**Nuclear Management Company, LLC**  
Prairie Island Nuclear Generating Plant  
1717 Wakonade Dr. East  
Welch MN 55089

**PRAIRIE ISLAND NUCLEAR GENERATING PLANT**  
Docket Nos. 50-282 License Nos. DPR-42  
50-306 DPR-60

**Supplement to License Amendment Request dated December 11, 2000  
Conversion to Improved Technical Specifications (ITS)**

**Staff Evaluation Review - Request for Additional Information**  
**Discussion of Changes**  
**Sections 3.3.1 - RTS Instrumentation & 3.3.2 - ESFAS Instrumentation**

3.3.2-12    L    58    (continued)

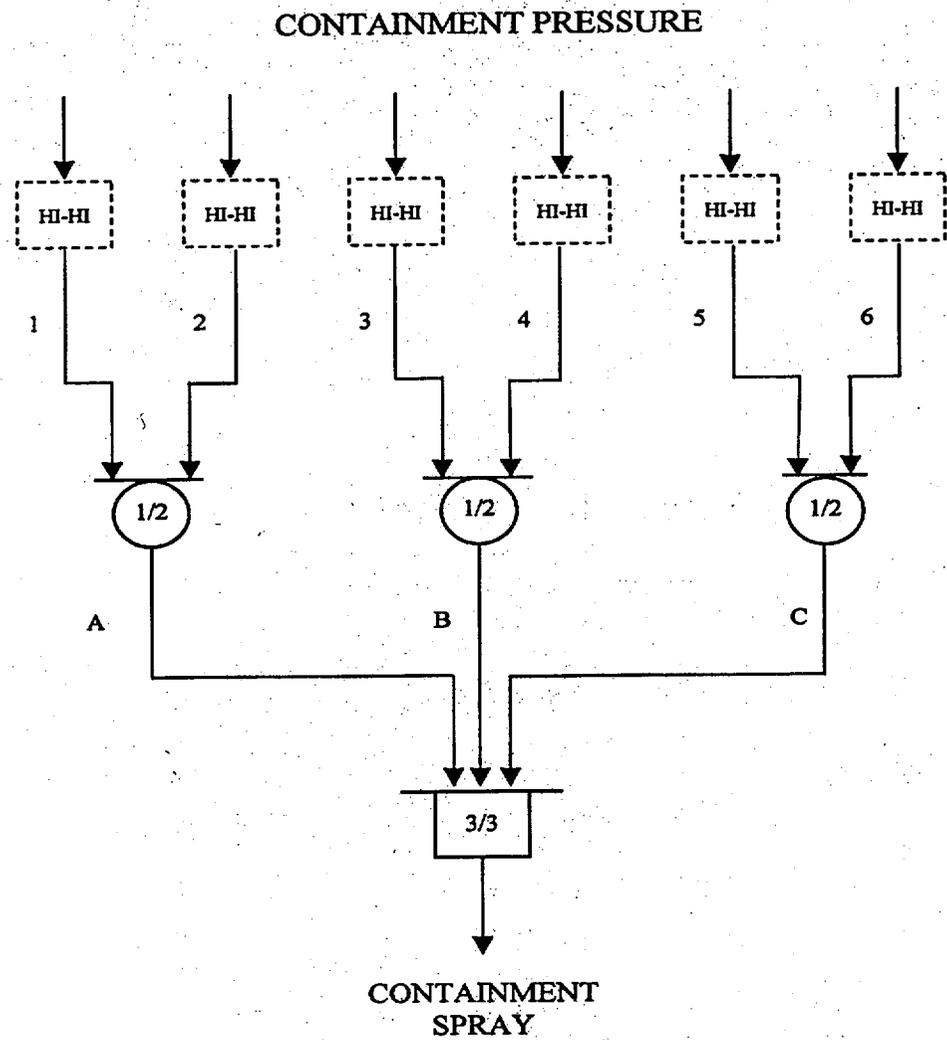
**ITS Condition E, however, represents a change to both CTS and to NUREG-1431. As proposed, required actions in Condition E permit indefinite plant operation with one channel in bypass. This less restrictive change to the PI licensing basis is not justified. Adopt NUREG-1431 Condition D or CTS for containment high pressure actuation of containment spray.**

There are six high-high containment pressure sensors which are combined in three sets of two. Each pair of two sensors input to OR-Logic to provide an output. The OR-Logic inputs to a 3-out-of-3 AND-Logic to provide an output to actuate CS. Thus, if one sensor in each set indicates High-High Pressure, CS is actuated.

CTS, through Table 3.5-2B Function 2b, defines a channel as the output at A, B or C on the figure with two sensors per channel. CTS defines the total channels as three channels OPERABLE with 2 sensors per channel and the minimum channels is three channels with 1 sensor per channel. To simplify the terminology and be consistent with ISTS terminology, ITS changed the definition of channel. ITS, through Table 3.3.2-1 Function 2c, defines each sensor as a channel.

Proposed 3.3.2 Condition E will allow indefinite operation with two ITS channels (CTS sensors) inoperable with one ITS channel (CTS sensor) in bypass. This may be a less restrictive change which is the reason for L-DOC L3.3-058. CTS will allow three sensors (ITS channels), one in each pair, to be inoperable provided they are tripped. However, as noted previously, with three channels tripped, CS will actuate so this is not practical flexibility which can be used. The intent of Condition E is to retain some of the CTS flexibility by allowing two ITS channels (CTS sensors) inoperable. With one ITS channel inoperable and RA D.1 met, one ITS channel in each of the other two sets are required to actuate CS. When a second ITS channel becomes operable, the effect on CS actuation depends on whether the channel is paired with the first inoperable channel or in one of the other sets. If the second inoperable channel is paired with the first inoperable channel, then there is no further impact on CS actuation since the signal is already present from tripping the first inoperable channel in that set. If the second inoperable channel is in one of the other sets, then tripping the second channel will cause two of the three required signals for CS actuation to be present. This would leave the plant vulnerable to actuation of CS due to a spurious signal from a single ITS channel.

As a compromise, ITS 3.3.2 Condition E proposes to place the second inoperable ITS channel in bypass. If the second inoperable channel is paired with the first inoperable channel, then again there is no further impact on CS actuation since the signal is already present from tripping the first inoperable channel in that set. If the second inoperable channel is in one of the other sets, placing this second inoperable channel in bypass still leaves one channel in that set to detect high-high pressure and provide a signal. The third set is unaffected. It is NMC's position that allowing only a single High-High Containment Pressure ITS channel to be inoperable is significantly more restrictive than CTS and is not necessary with 1-out-of-2, three-times logic. The Prairie Island design for this Function differs from both of the designs on which ISTS is based and therefore, ISTS Condition D is not appropriate. CTS should not be retained because it will allow actions which will actuate CS which could create a safety consideration and the definition of channels could be confusing. Based on the discussion in DOC L3.3-058 and NSHD L3.3-058, the proposed ITS with the first inoperable ITS channel tripped and the second inoperable channel bypassed is not a significant safety hazards consideration and should be an acceptable ITS for Prairie Island. No changes have been made to the ITS submittal in response to this RAI.
